# A-5-LGB-20-0050 (DIG COAST INN, LLC) JULY 28, 2021

### **BLUFF EDGE REVIEW MEMORANDUM**

Re: 1401 S. Coast Highway, Laguna Beach (Coast Inn),

Appeal No. A-5-LGB-20-0050

Figure 1 (above): Cross-sectional profile of coastal bluff at Mountain Rd., north of Coast Inn

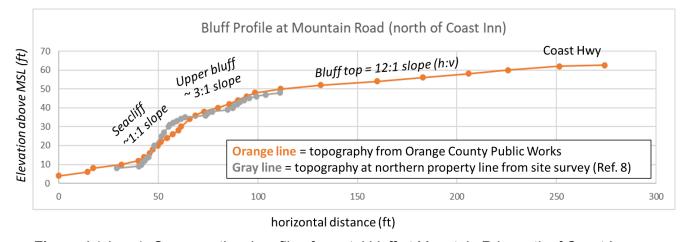
As shown in **Figs. 1** & **2** (above), along the Mountain Rd. street end and the northern edge of the subject site, the transition from bluff top to bluff face is incremental – the bluff edge is "rounded away from the face of the bluff" – but the gradient increases noticeably at two points, the first at approximately +48 feet MSL and the second at about +30 feet MSL. Per the LUE definition, the bluff edge occurs at the higher elevation slope break at +48 feet MSL, which is "the point nearest the bluff face beyond which a downward gradient is maintained continuously" (accounting for the fact that the bluff top itself has a downward gradient of about 5 degrees).

**Figure 3: Mid-Site Geologic Cross-Section**

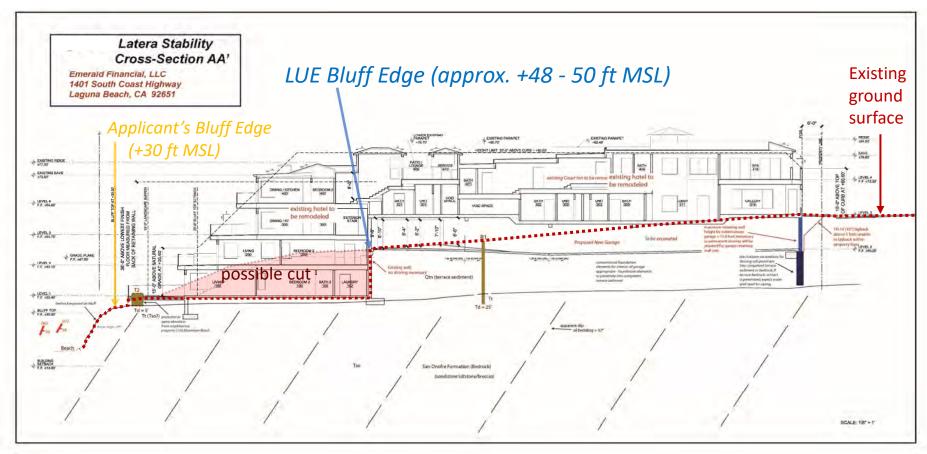
The bluff edge determination provided by the applicant (Ref. 8) identified the bluff edge at the contact between the San Onofre Breccia bedrock and the overlying upper bluff material, at an elevation of approximately +30 feet MSL (**Figs. 3, 5**). This bluff edge line corresponds to the most distinct slope change on the bluff, where the gentle upper bluff slope transitions to the steeper sea cliff. However, as noted above, the LUE definition of "Oceanfront/Coastal Bluff" expressly includes the entire slope between the upland area and the sea, not just the steeper sea cliff, which in Laguna Beach often corresponds to the lower bluff bedrock. The applicant's analysis does not account for the considerable elevation change that occurs between the identified bluff edge (at +30 ft MSL) and the top of the marine terrace (at 50 - 60 ft MSL), nor the gradient ( $\sim$ 2.5:1 to 3:1 h:v) of the upper bluff, which significantly exceeds the general slope of the bluff top ( $\sim$ 12:1 h:v) in this location.

Across most of the subject site, however, the situation is complicated by the fact that the existing Coast Inn building appears to have been built on one or more graded "steps" cut into the bluff when the site was developed (**Figs. 2 - 4**). As noted above, the LUE bluff edge definition considers grading cuts to be equivalent to natural erosion as a "process" than can change the position of the bluff edge. It is likely that this prior grading of the upper bluff at the Coast Inn site removed a rounded natural bluff edge similar to that occurring along the Mountain Rd. street end. However, if even if the upper bluff "step" on which the hotel is built is of natural origin, the LUE Coastal Bluff Edge definition indicates that in cases where there is a "step like feature" at the top of the bluff, the bluff edge is the "landward edge of the topmost riser." At the project site, the edge of the topmost riser occurs at an elevation of approximately +48 – 50 feet MSL (**Figs. 3, 4**). This elevation is consistent with the LUE bluff edge on the less altered bluff along the northern property line (**Fig. 1**). The LUE bluff edge is shown in plan view in **Fig. 5**, more or less coincident with the retaining wall at the back of Level 2 of the hotel and approximately 65 feet inland of the western property line.

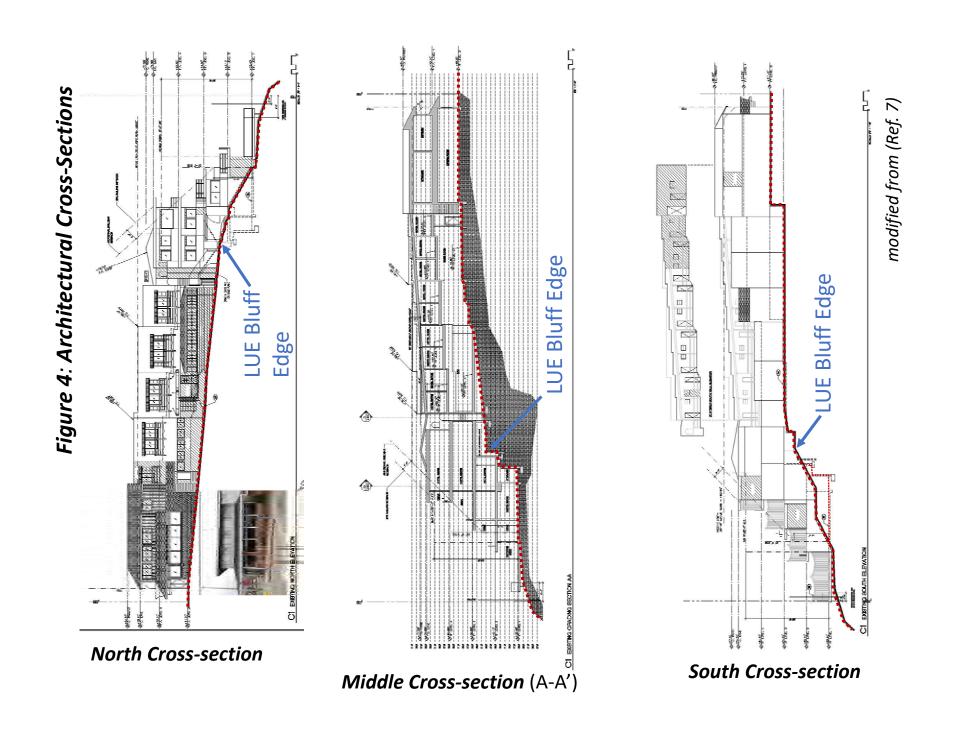
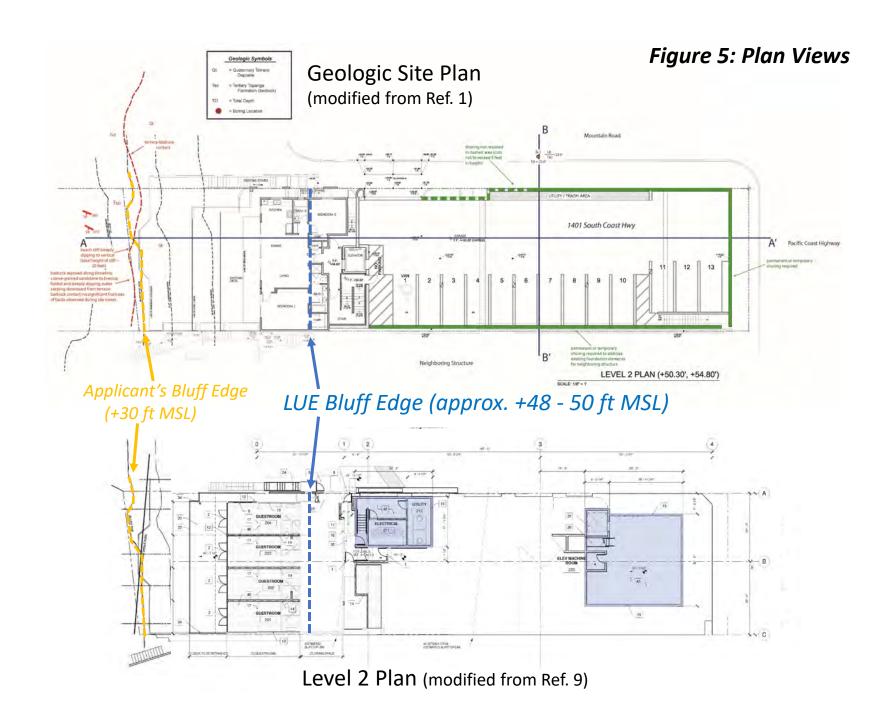
during past development. These modifications appear to include grading cuts associated with the construction of the existing Coast Inn building (**Figs. 3, 4**).
